HISTORIC AND DESIGN REVIEW COMMISSION

March 3, 2021

HDRC CASE NO: 2021-074
COMMON NAME: ROW near 121 S Flores
ZONING: D, RIO-7B
CITY COUNCIL DIST.: 1
APPLICANT: Kevin Bowyer/Modus LLC
OWNER: CITY OF SAN ANTONIO
TYPE OF WORK: Replace an existing streetlight pole with a new pole with network node equipment
APPLICATION RECEIVED: October 06, 2020
60-DAY REVIEW: Not applicable due to City Council Emergency Orders
CASE MANAGER: Huy Pham

EXISTING PHOTOS
(W SIDE OF S FLORES ST, BETWEEN DOLORSA AND W NUEVA INTERSECTIONS)

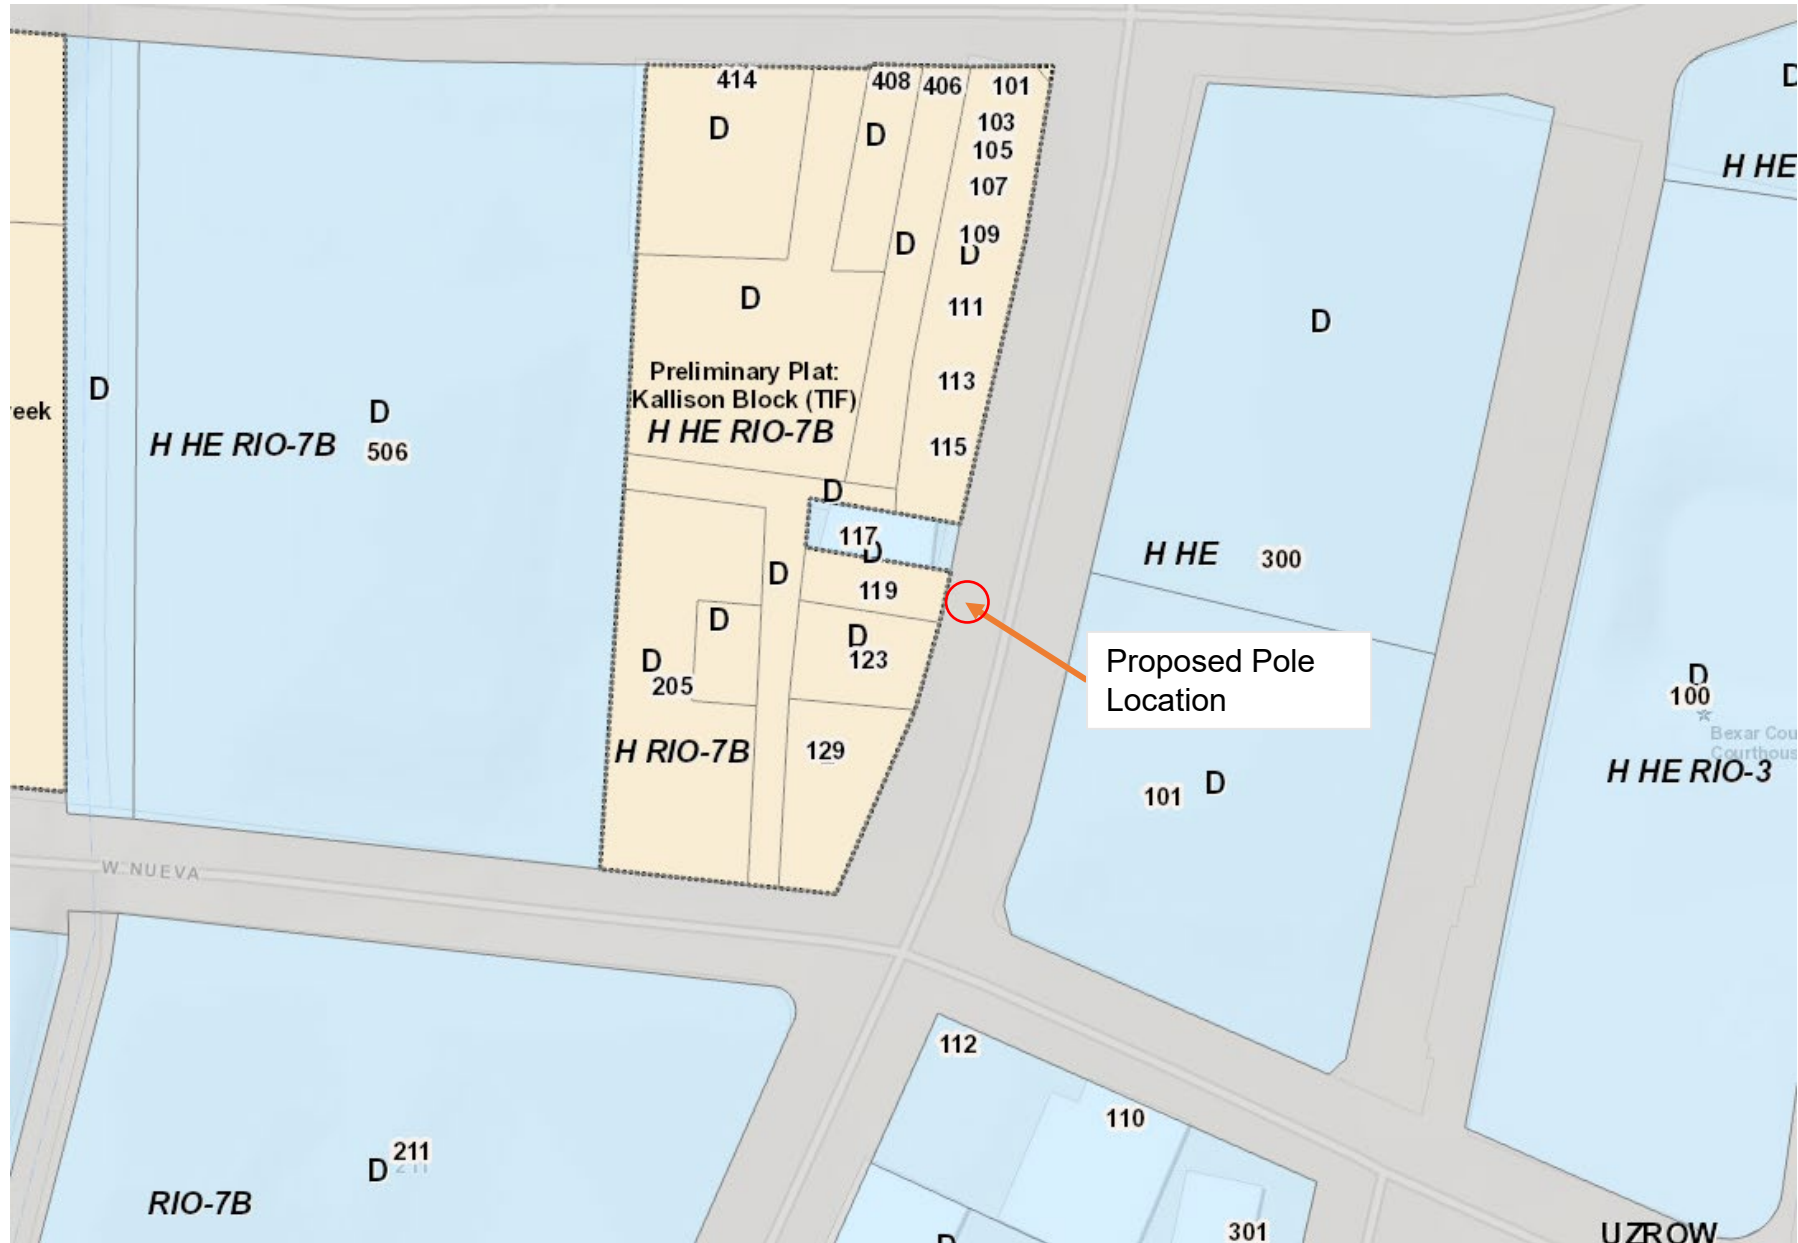
This application was originally on the October 21, 2020 HDRC agenda but was subsequently pulled off the agenda by a couple members of the HDRC due to concerns of the pole being directly in front of the front façade of the adjacent building.

Verizon met with the HDRC subcommittee on October 28th, 2020 to discuss the concerns some of the commission members had regarding the location of the replacement CPS streetlight. Directive from that meeting was to explore options with CPS on the feasibility of shifting the replacement of the replacement streetlight to a location that would be between two buildings rather than directly in front of the façade.

Verizon broached this question to CPS. CPS reviewed this location and did their own internal photometric study to ensure that the shift of the lighting structure would not impact their street lighting requirements in the area. Unfortunately, CPS informed us that they would not allow for the shift in location due to concerns over the negative impacts on the lighting along Flores St.
